# NORTHEAST UTILITIES

Millstone Nuclear Power Station, Unit No. 1  
Additional Information Regarding  
Appendix R Control Room Exemption Request

Additional Information Regarding  
Control Room Halon Fire Suppression System

### ADDITIONAL INFORMATION REGARDING APPENDIX R CONTROL ROOM EXEMPTION REQUEST

PHOTO #1

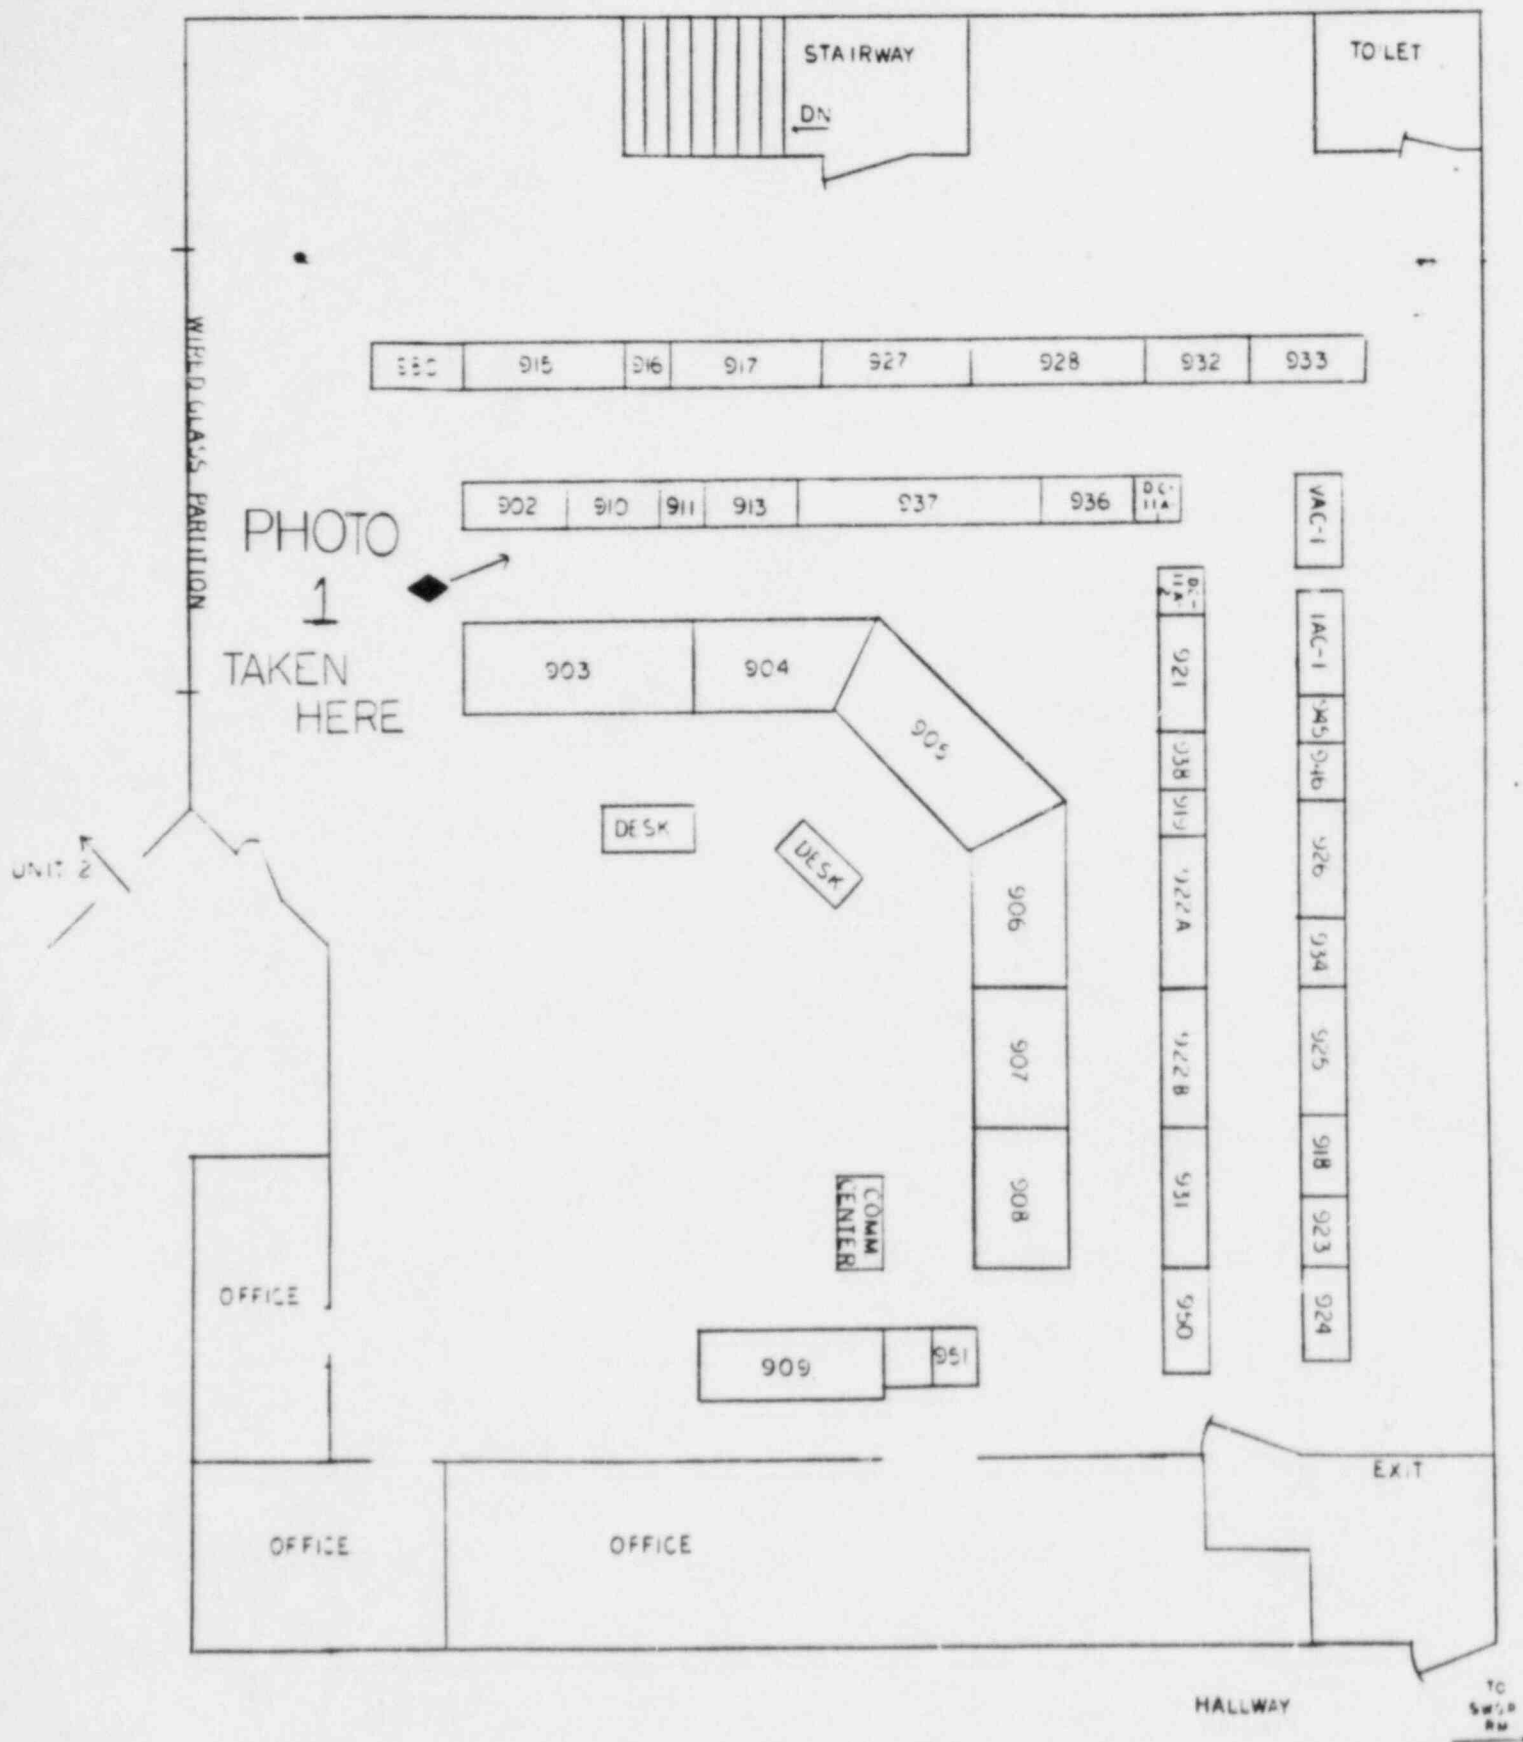
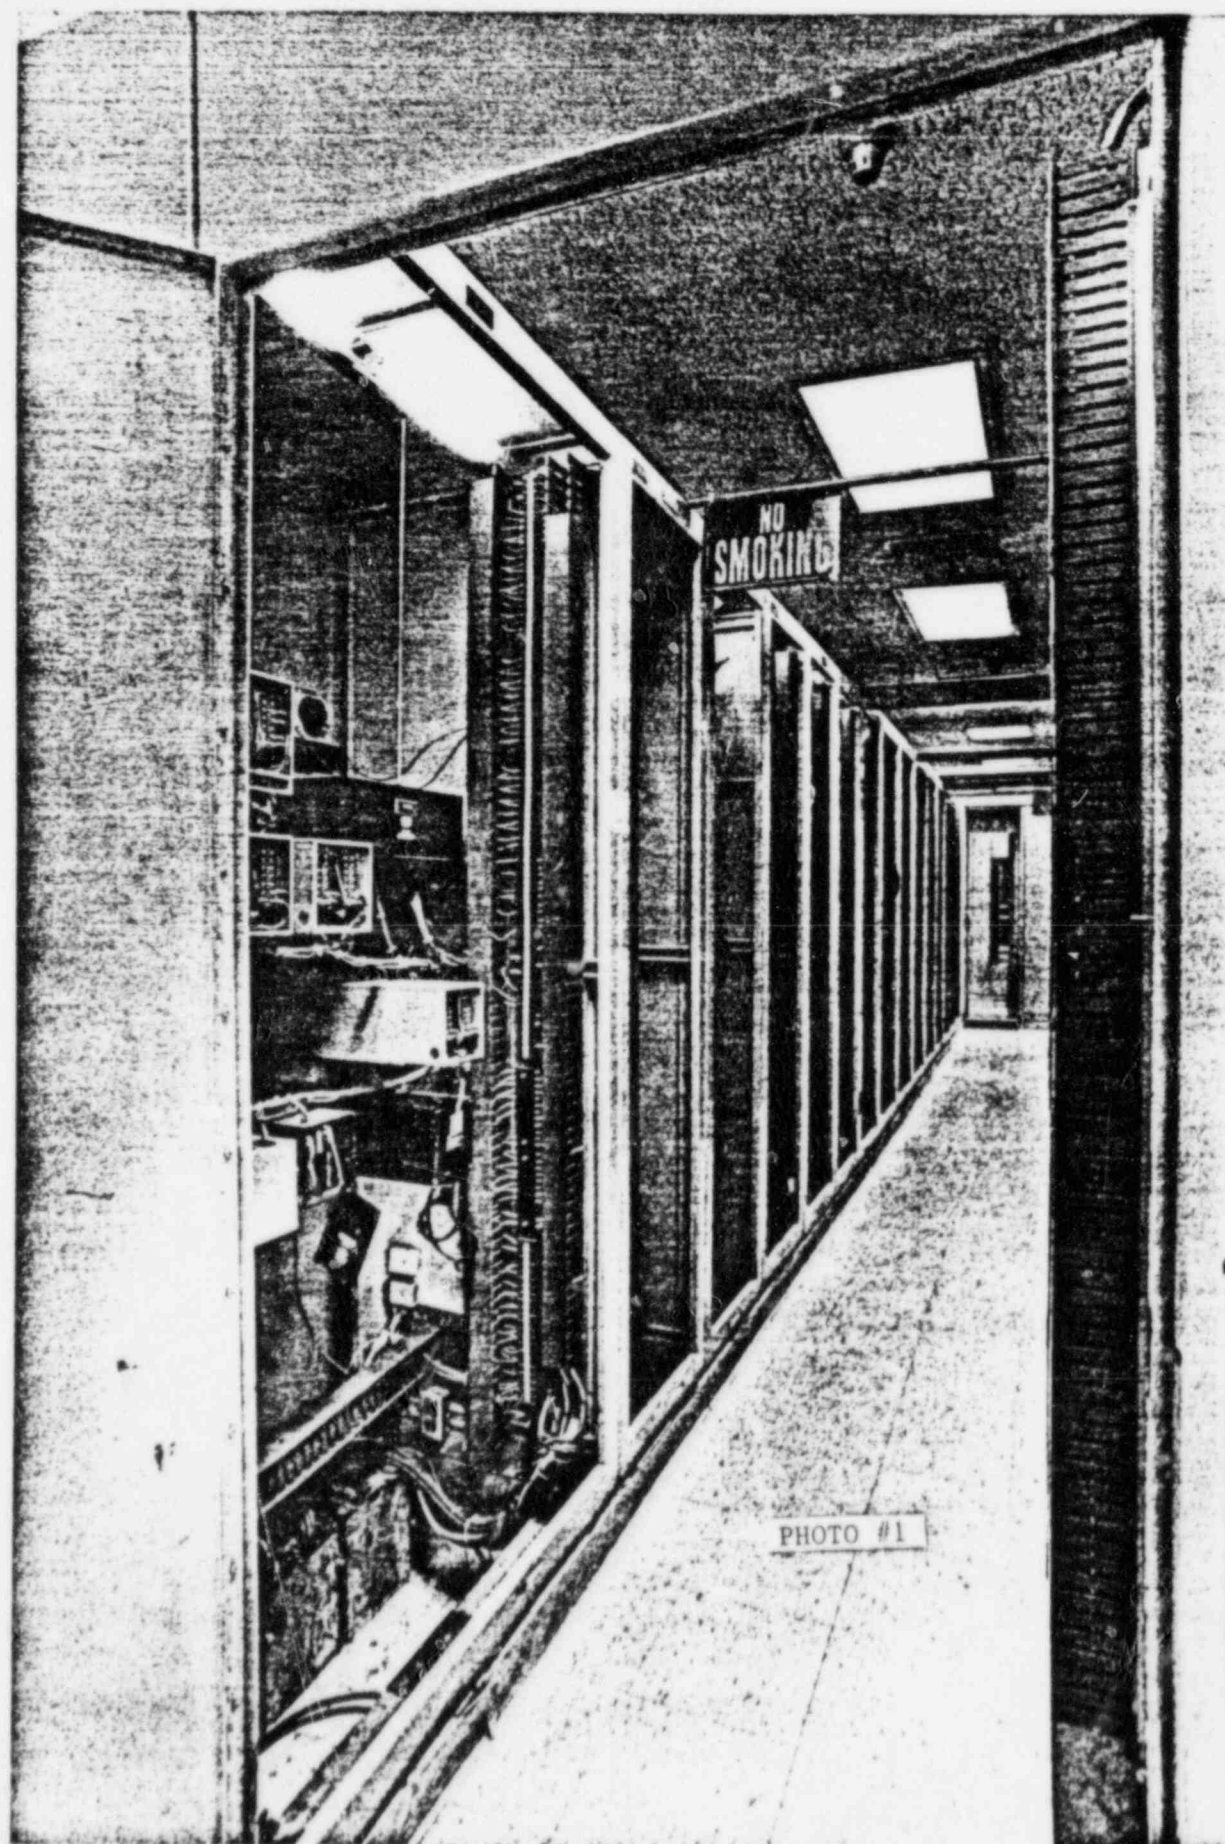
2. Provide a detailed system description of the Halon fire suppression system and provide more information on the spacing between the main control panels and the auxiliary panels.

Back of Auxiliary Panels 902 to DC-11A-1 looking from left side of Main Control Board Doorway.

- NOTE:
- o Open back on Panels 902 through 936
  - o Smoke detection exists independent from proposed halon system detectors.
  - o Sheet metal separates each panel.
